APPLICATION NO:
F/2001/3382

PROPOSAL:
Proposed formation of new vehicular access and blocking off of existing access.

Notification of Refusal of Permission

Location:	Broomfield, Lower Sandhurst Road, Finchampstead
Proposal:	Proposed formation of new vehicular access and blocking off of existing access
Application Number:	F/2001/3382

SOUTH ELEVATION

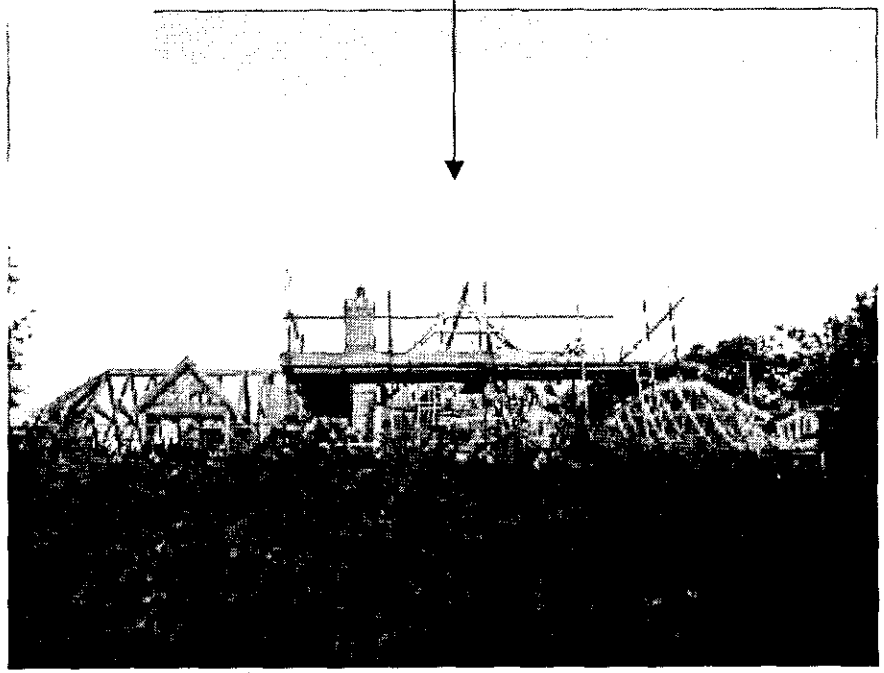
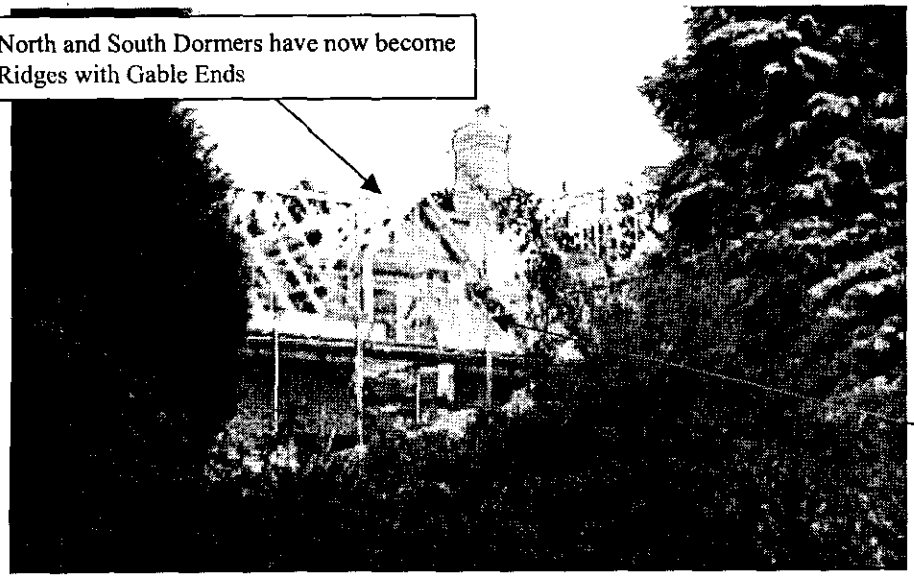
1 Approved: Small **Dormer** in Sloped Roof as approved Aug 2001
(Note Continuous main roof line to verandah at ground floor level)

3 Tree removed 7th Aug 2001 from South border with Road exposes huge Ridge and Gables to open view

North and South Dormers have now become Ridges with Gable Ends

2 Actually Built: Large Picture Window, Extending below "roof-line"
No apparent intention to bring roof-line down to ground Floor Level
Note also:-
Large N-S Ridge now extending continuously to rear of house
